NP-12-0021  
May 31, 2012

Subject: Exelon Nuclear Texas Holdings, LLC  
Victoria County Station  
Early Site Permit Application  
Environmental Report – Response to ER RAI Letter No.5  
Docket No. 52-042

**ESP EIS 9.3.1-1 (eRAI No.6394, RAI Letter No. 5):****NRC Request:****ESP EIS 9.3.1-1**

Figure 1 ERCOT Map with Depiction of Adequate Water Areas

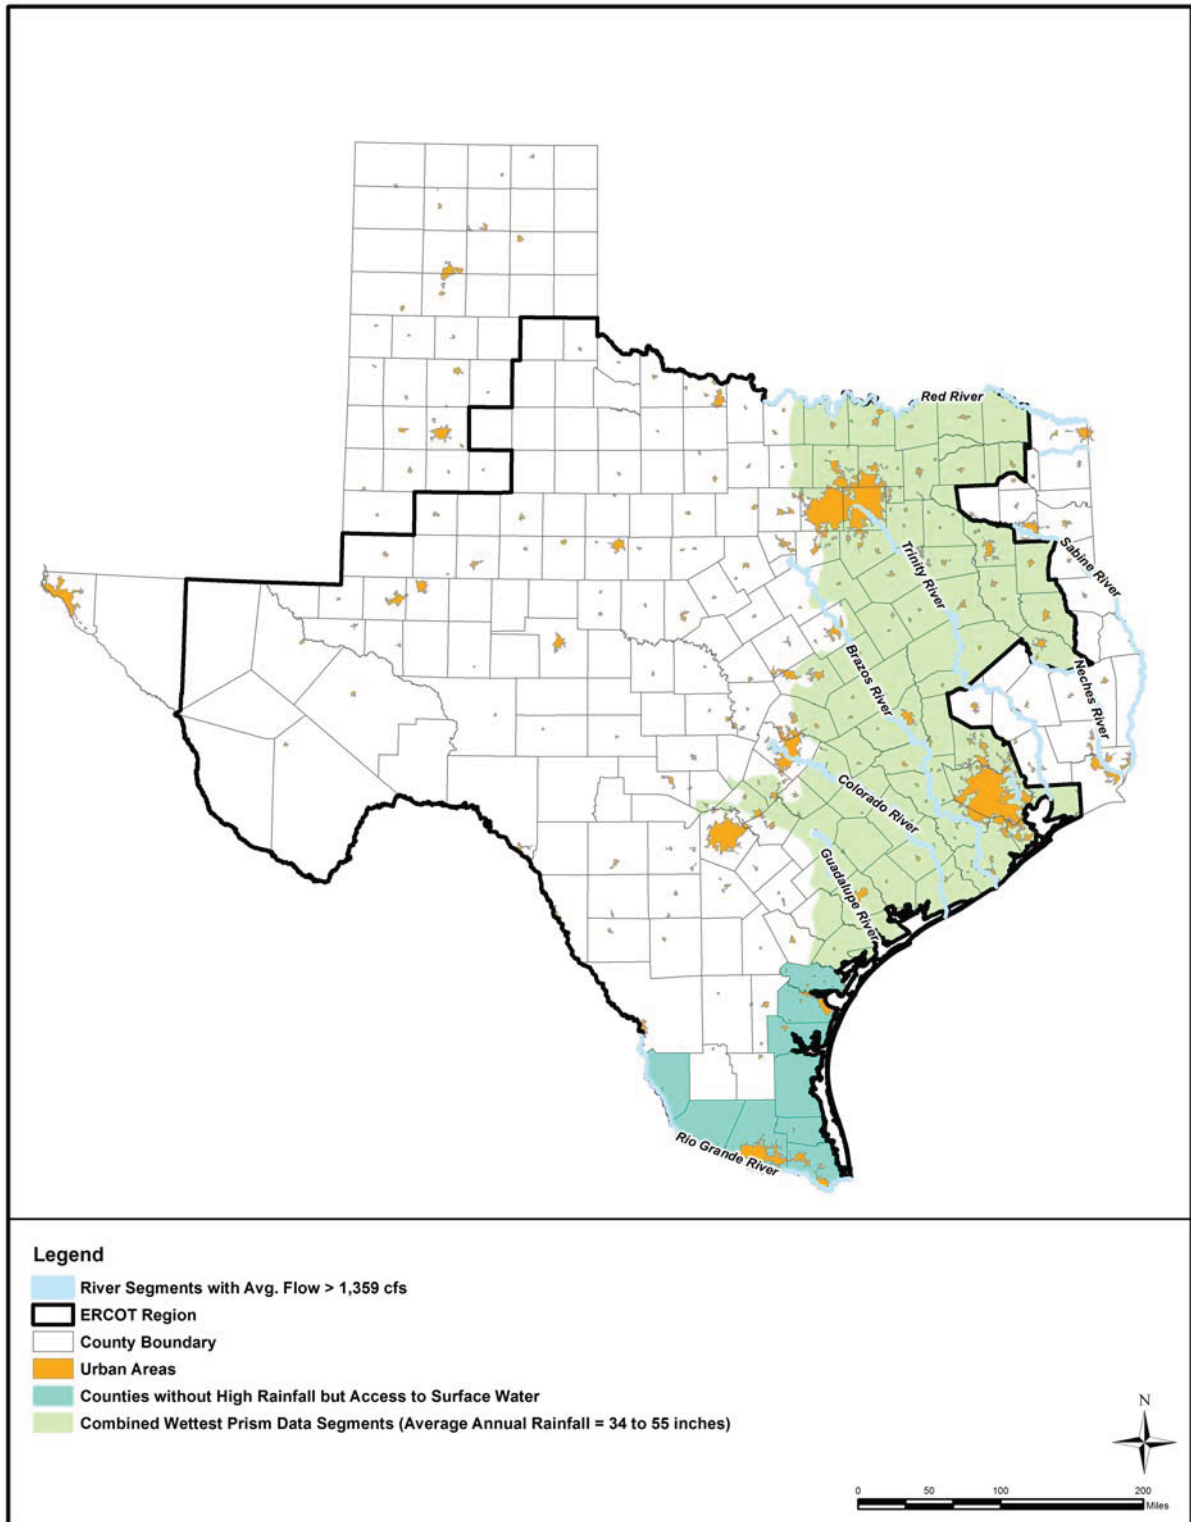
The ESRP Section 9.3 requires NRC to review the process by which the applicant has identified and evaluated alternative sites for the proposed action. Details of the applicant's site selection methodology must be available to support the NRC's evaluation of its reasonableness and to make sure that there is no other site that is obviously superior to the one being proposed by the applicant. This requires an analysis of alternative sites to support the determination of whether there is an obviously superior site in terms of overall environmental impacts and costs when compared to the site proposed by the applicant. Selection of candidate areas was separate from identifying and evaluating candidate sites and sufficient details of the decision-making process were not provided in the ER. Provide a discussion regarding the manner in which the candidate areas in the site selection process for the alternative sites were identified. Include all of the factors that influenced these selections and the values assigned to each criterion.

To verify that the “adequate water area” selected using the PRISM data was consistent with the site selection estimate of 61,000 gpm (135.9 cfs), Exelon analyzed surface water flow characteristics for major rivers in Texas using GIS data compiled by the U.S. Geological Survey (USGS 2003). Specifically, USGS gaging stations with an average daily stream flow greater than 10 times the estimated maximum consumption rate for the project (or average flow greater than 1,359 cfs) were identified. Applying a flow rate of 10 times the project requirement resulted in identifying river segments that have the physical availability of water to supply the new facility and a reasonable potential to acquire the necessary cooling water supplies. The gaging station most upstream on each major river meeting the flow requirement was identified as the point below which the river possesses sufficient flow to be identified as a viable cooling water source. The major rivers were then split into two segments at these locations: the upstream segment not meeting the flow requirement, and the downstream segment meeting the flow requirement. The river segments meeting the flow requirement are depicted in Figure 1, along with the adequate water area defined using the PRISM data.

Figure 1 indicates good correlation between the major river segments with sufficient flow and the wettest areas from the PRISM dataset, confirming the selection of the adequate water area. Figure 1 also shows that the lower portion of the Rio Grande River basin appears to have adequate physical water availability to support a new nuclear facility. Despite low average annual precipitation in the southern portion of Texas, the large size of the Rio Grande River watershed (approximately 176,000 square miles of contributing area) results in the observed average flow rates (RGRWPG 2006). Accordingly, counties in the lower Rio Grande basin were retained for further consideration.

Coastal counties not already within the adequate water area determined from the PRISM data were also examined as potential sites for saltwater cooled plants (see Figure 1).

**Figure 9.3-2b. Counties Remaining After Application of Exclusionary and Suitability Criteria**

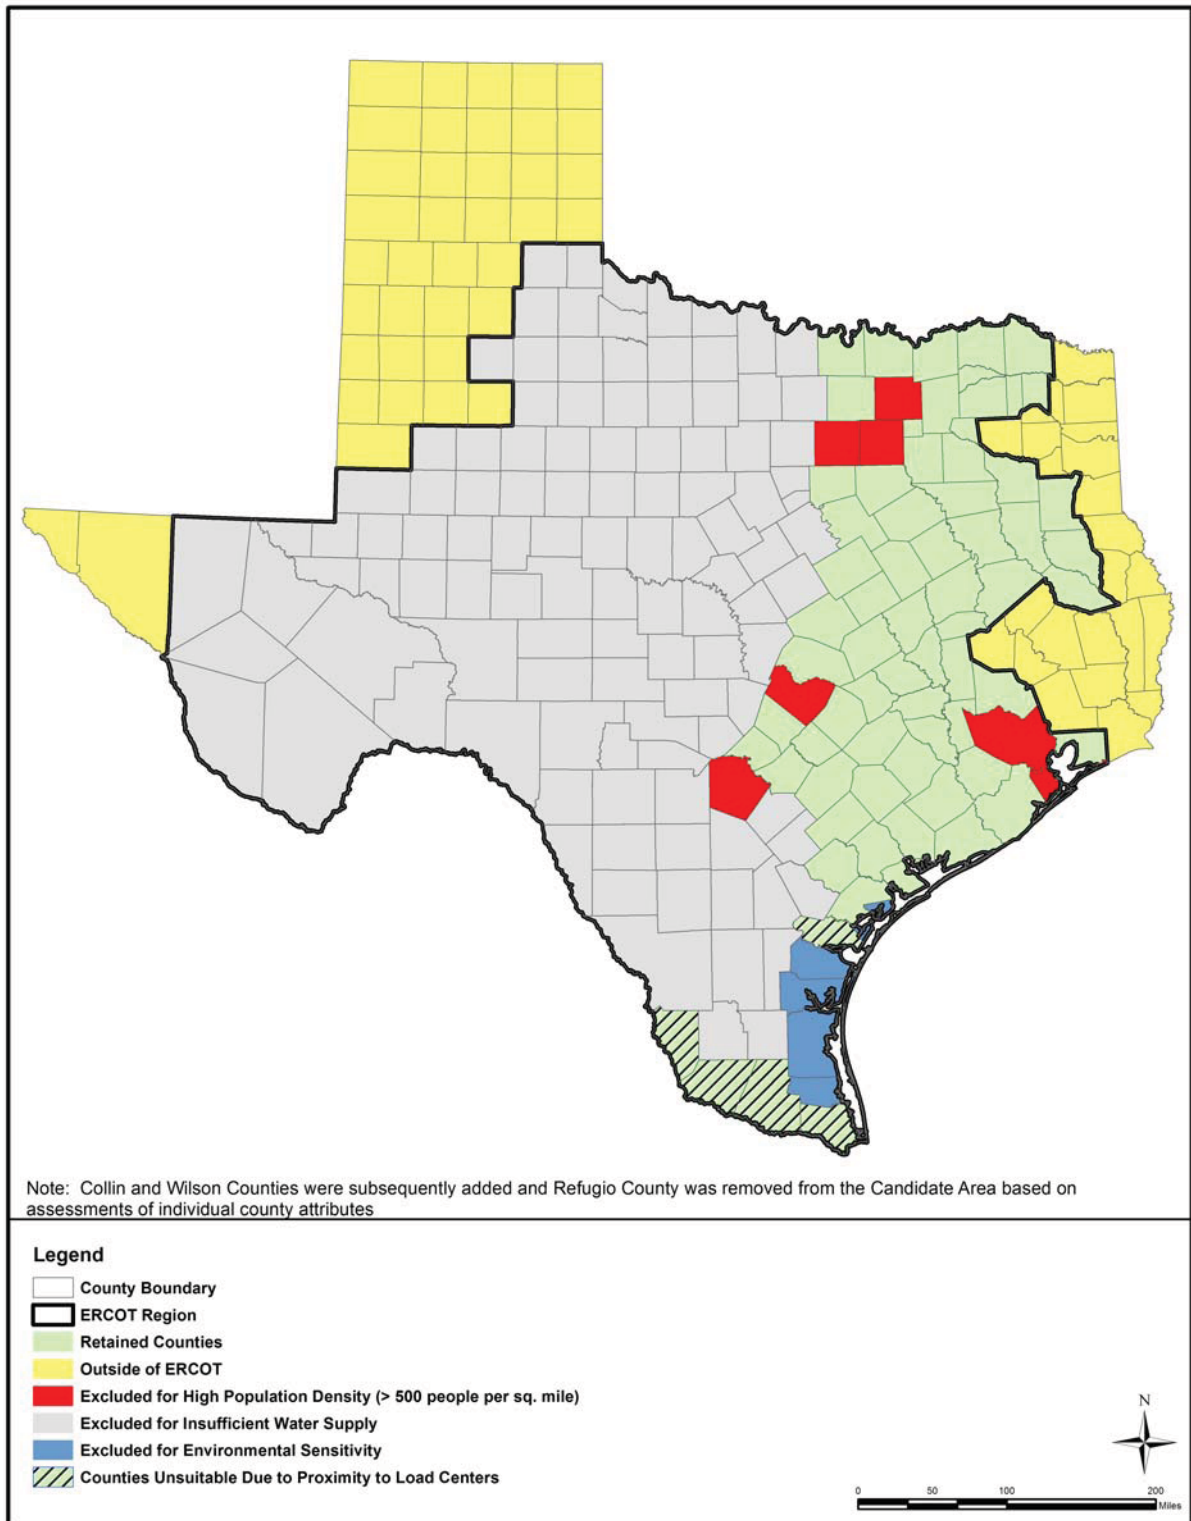
Figures 9.3-2 and 9.3-3 will be replaced with Figures 9.3-2a, 9.3-2b, and 9.3-3 in a future revision as indicated below.

Application of the above exclusionary and suitability criteria yielded ~~two~~ a candidate areas of 66 counties viewed to be favorable for the ESP project, ~~as shown in Figures~~

9.3-2a and 9.3-2b summarize the application of exclusionary and suitability criteria during Candidate Area selection. Figure 9.3-3 presents the Candidate Area counties.
